**BUDDEROO NATIONAL PARK,  
MACQUARIE PASS NATIONAL PARK,  
BARREN GROUNDS NATURE RESERVE AND  
ROBERTSON NATURE RESERVE**

**Amendments to the 1998  
Plan of Management**

**NSW National Parks and Wildlife Service**

**March 2004**

# Carrington Falls

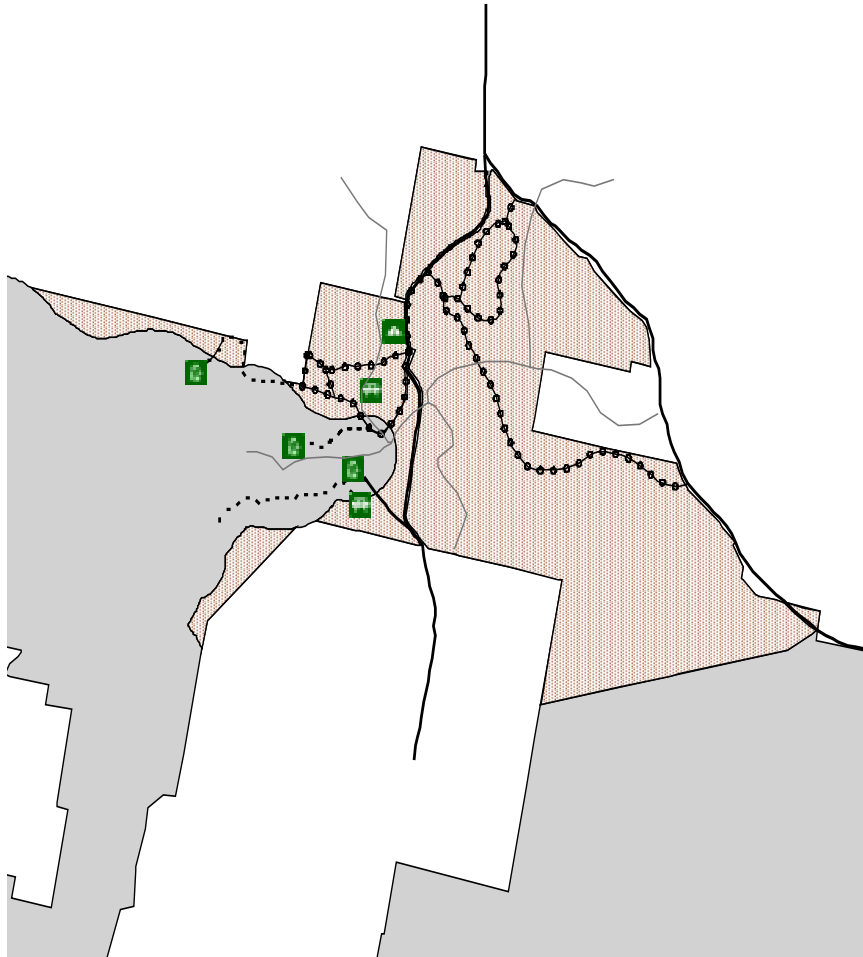
9. Section 4.3.2 (page 35 policy 3) of the 1998 plan states, *“Horse riding will not be permitted within the parks and reserves.”*

Include map of designated horse trails in plan.

*“Horse riding will only be permitted on designated trails in the Carrington Falls area of Budderoo National Park (see map). If necessary, measures will be implemented to reduce any impacts that may arise, such as temporary closure, limits on numbers or introduction of a permit system. Individual trails may be permanently closed to horse riding if impacts occur that are of a continuing and unacceptable nature. Licences for commercial equestrian use will not be issued.”*
